DEVIATION REQUEST (Attach diagrams, figures, and other documentation to clarify request)

A deviation from the standards of or in Section **2.3.2** of the Engineering Criteria Manual (ECM) is requested.

HAVEN FOREST SCHOOL
5490 BURGESS ROAD, EL PASO COUNTY, CO

(P) BURGESS ROAD WIDENING SECTION
TYPICAL SECTION B
H-1/4" = 1"

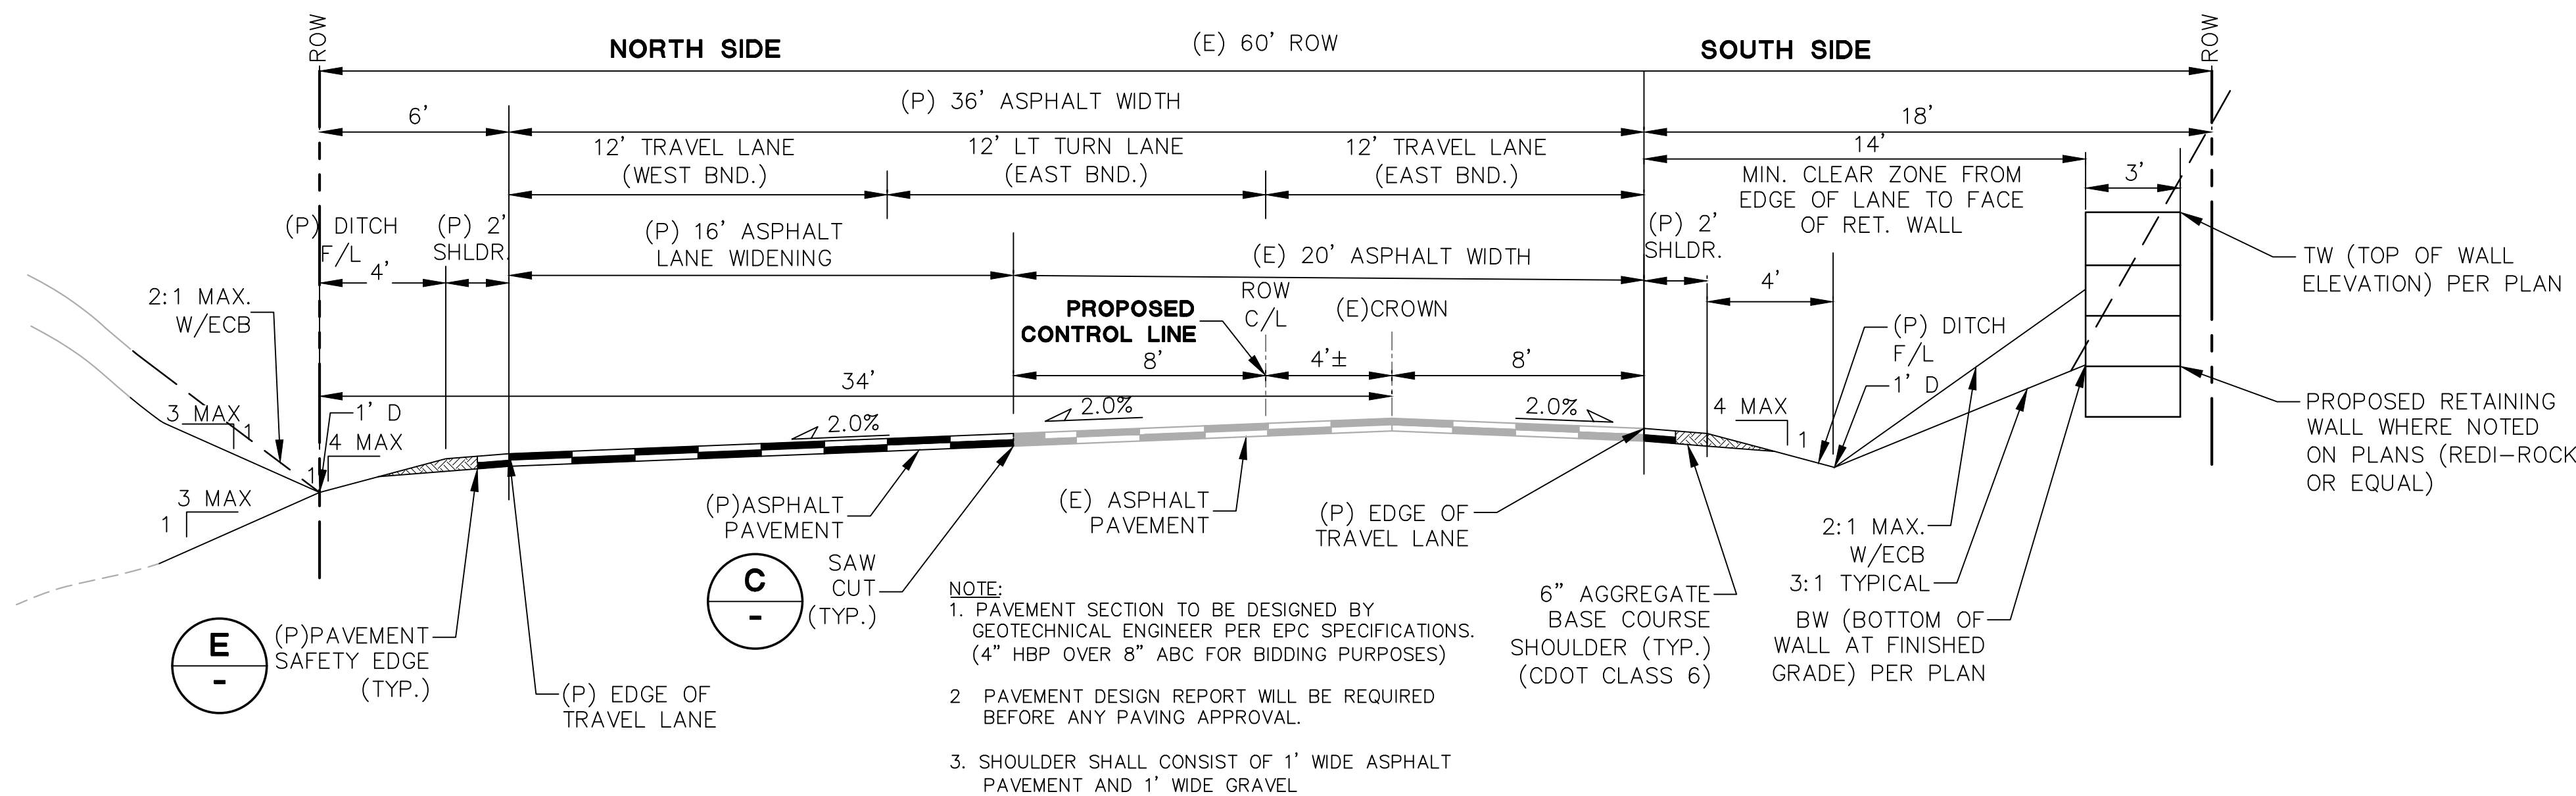
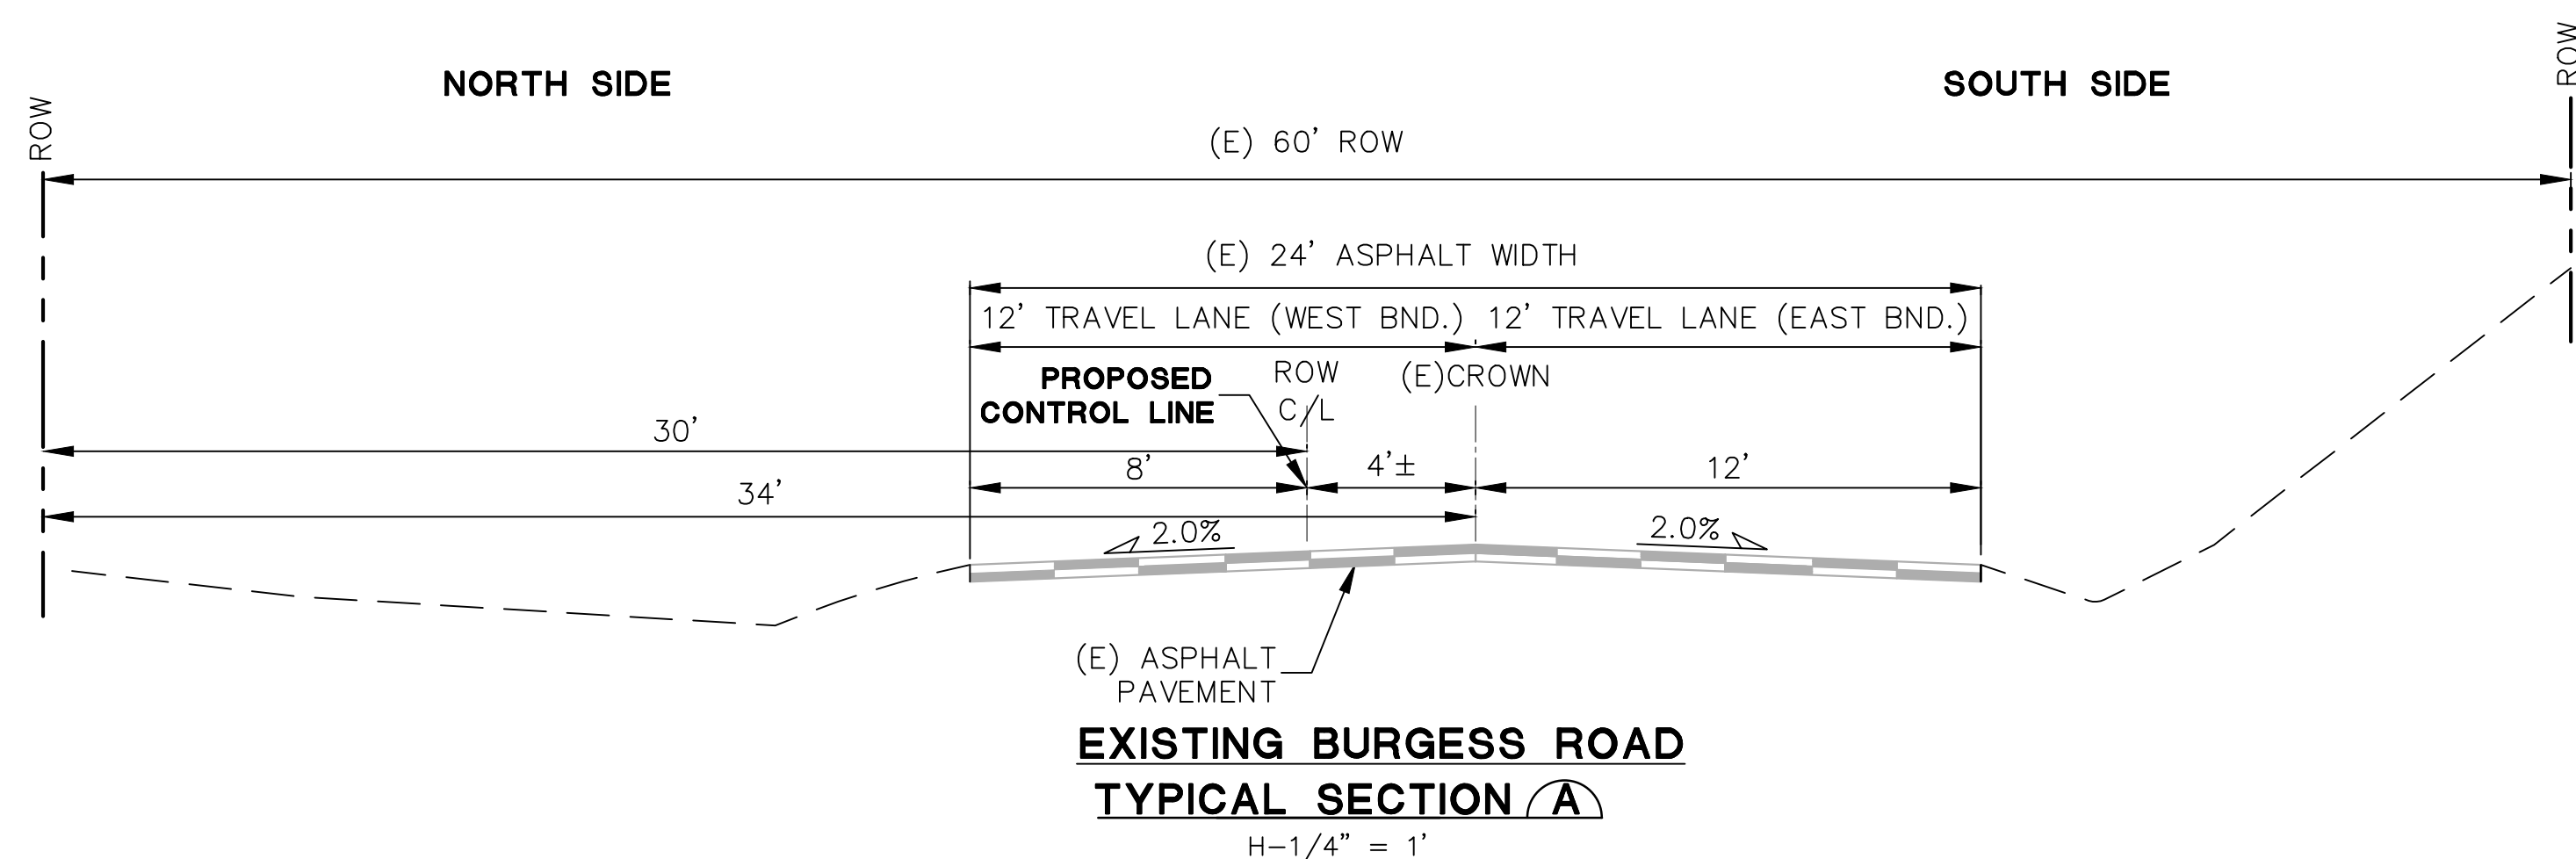
Add to deviation and address:

Clear Zone requirements from ECM standard to proposed.

Line of Sight and entering sight distance from east and limitation for single unit trucks or school buses as detailed in TIS.

If lane configuration, tapers offset etc based on DPW Traffic engineer redlines will not be met then they would have to be included in the deviation.
